CITY OF SUPERIOR
C. Reiss Dock
RFQ #23-17-PL

ADDENDUM #5

DATE: April 28, 2023

This addendum modifies the Proposal Documents for the above listed project. The addendum consists of 63 pages.

M001

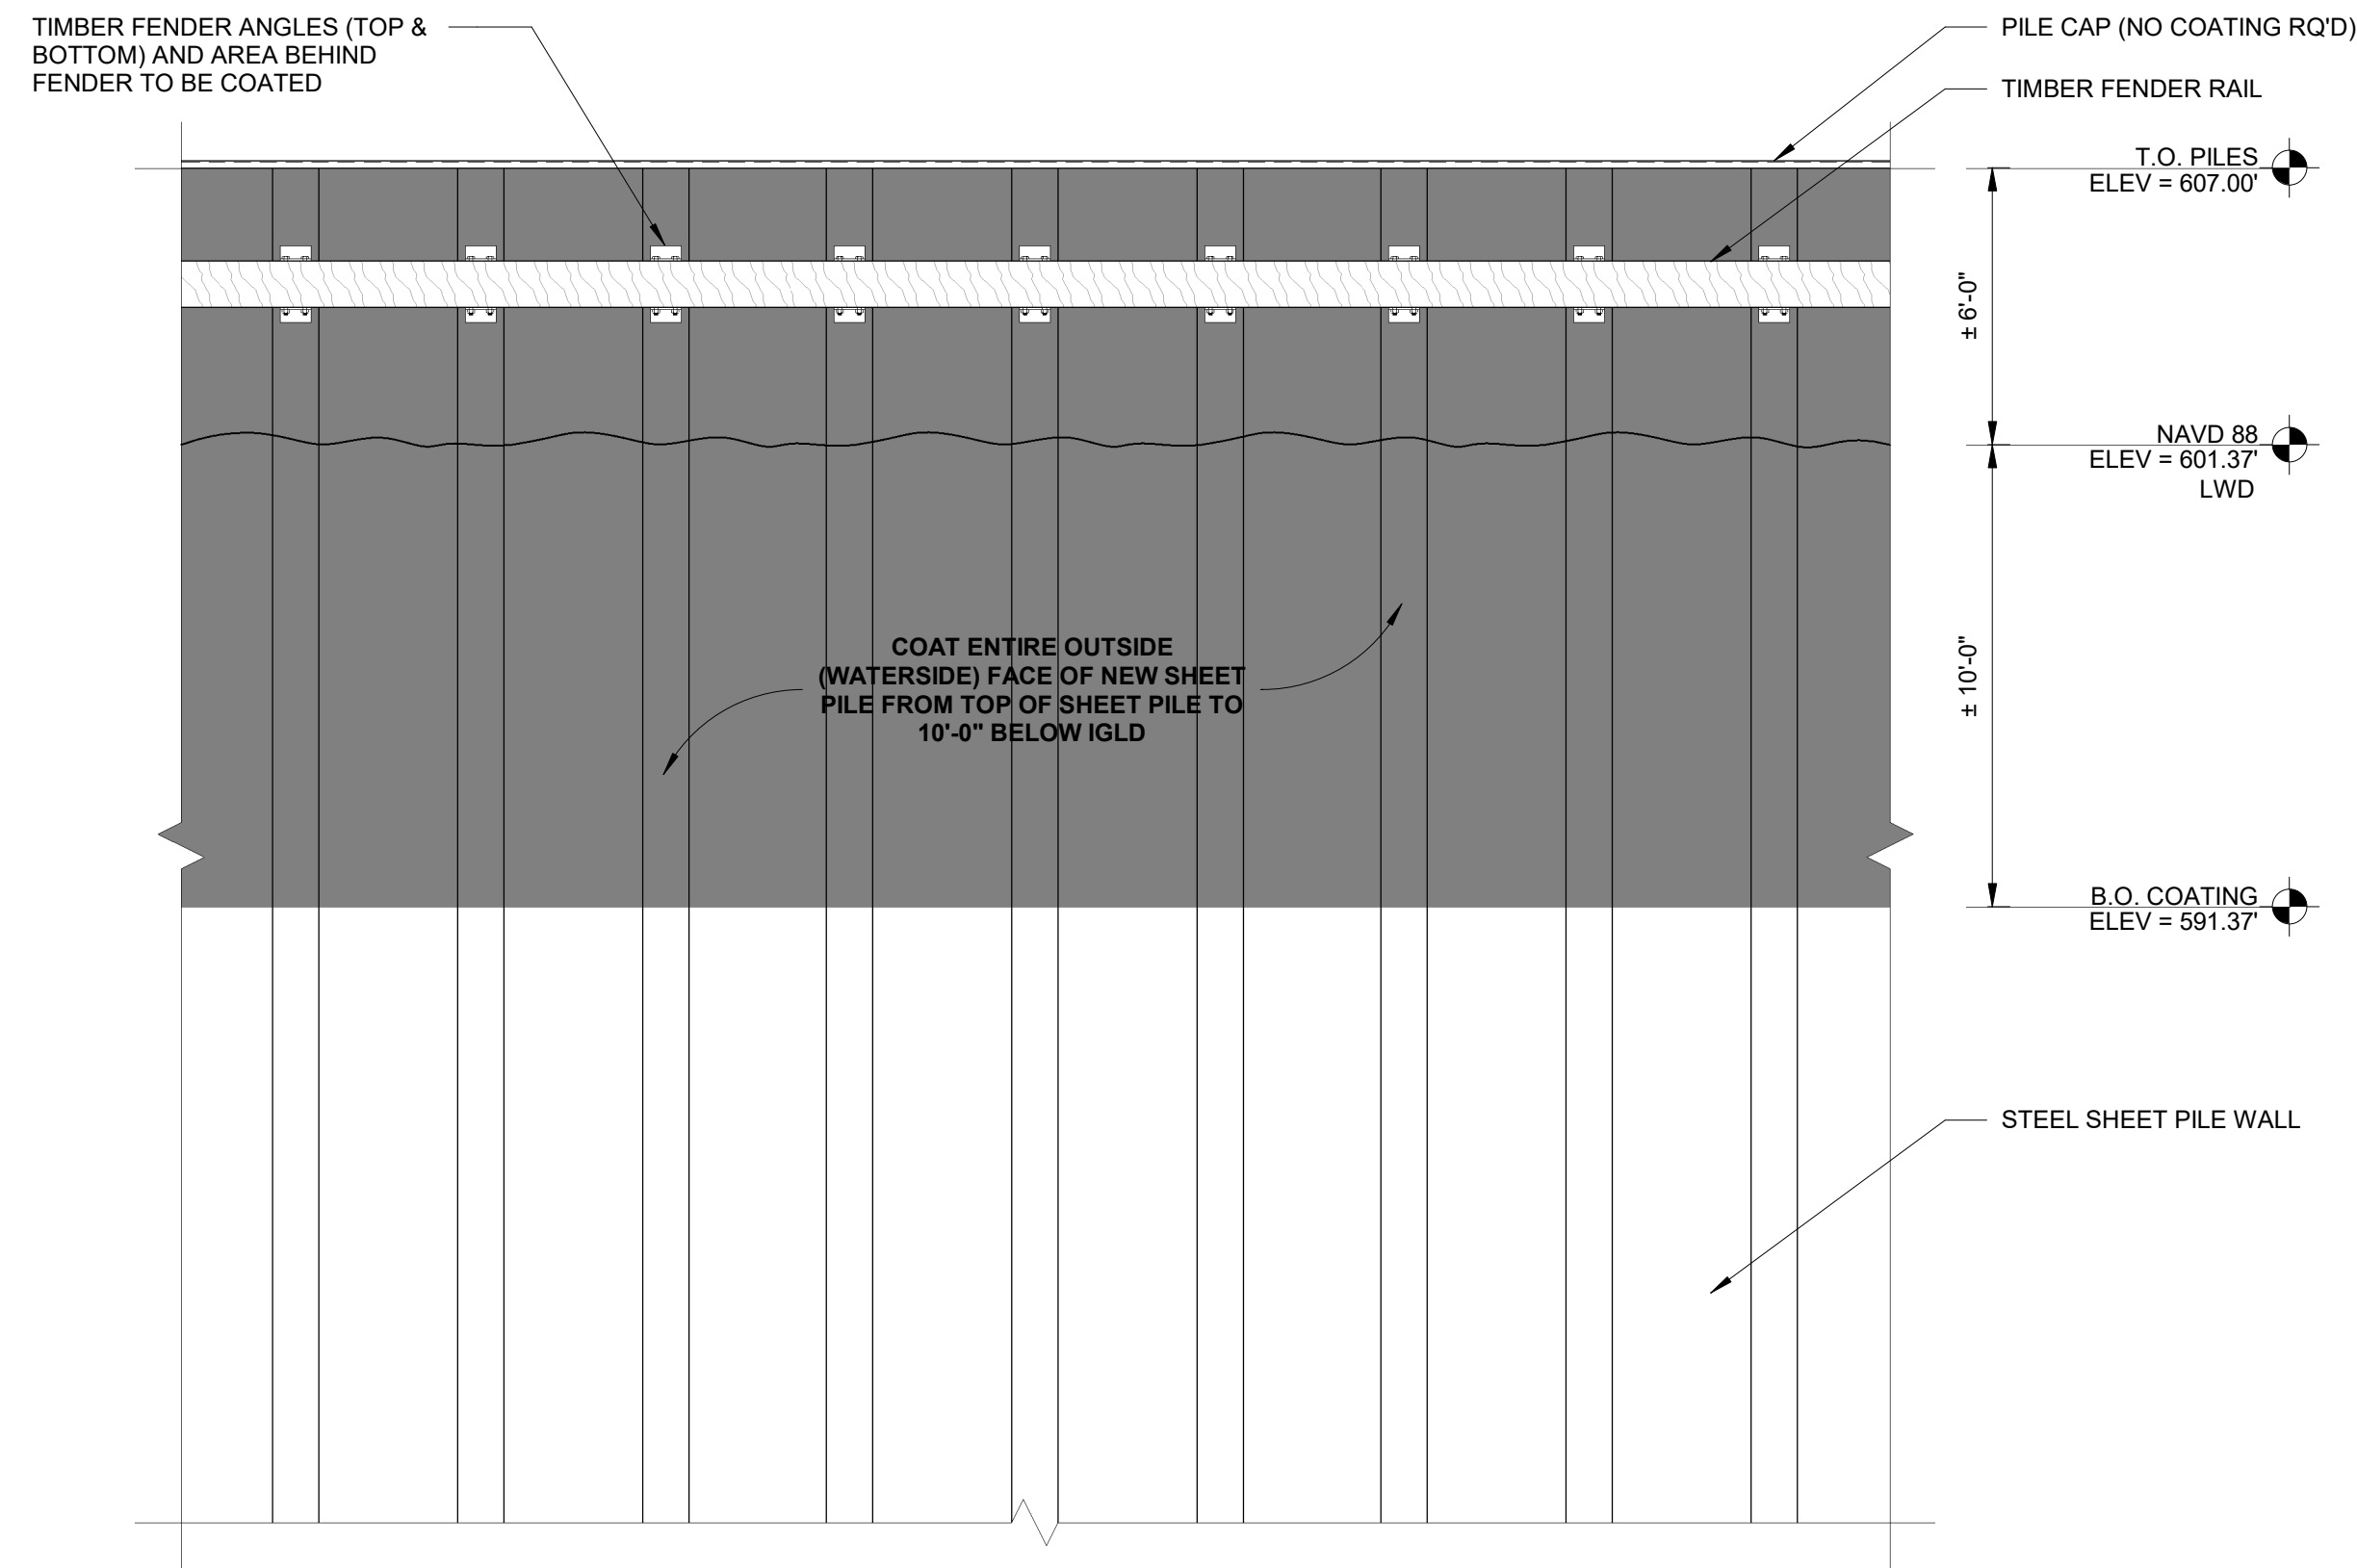
a. Relating to bid item quantity: The way the note on drawing M001 reads, the entire length (2,600'+/-) should be surveyed and cleared. However the bid item is only for 1,000 LF. Can you clarify if only a certain portion of the wall needs to be cleared and where that is? Or revise quantity if necessary to whole wall length.

Plan Sheet – M-001

1. Pre-construction underwater survey notes added.

A: Driving obstructions not identified in the survey will be addressed on a case-by-case basis. Specification section 02 41 13 and Sheet M001 are modified to provide separate out underwater sonar survey and driveline clearing into separate bid items. Underwater Driveline Survey (Lump Sum) bid item has been added. The driveline clearing will be broken out into two different bid items to allow for more flexibility in pricing since the quantity of clearing required is unknown. Driveline Clearing (1 LF - 260 LF.) has been added for clearing work up to 260 lineal feet in cumulative quantity. A second bid item (Driveline Clearing (261 LF -2600 LF) will be used to pay for driveline clearing for each additional lineal foot that exceeds the initial 260 lineal feet of cumulative quantity.
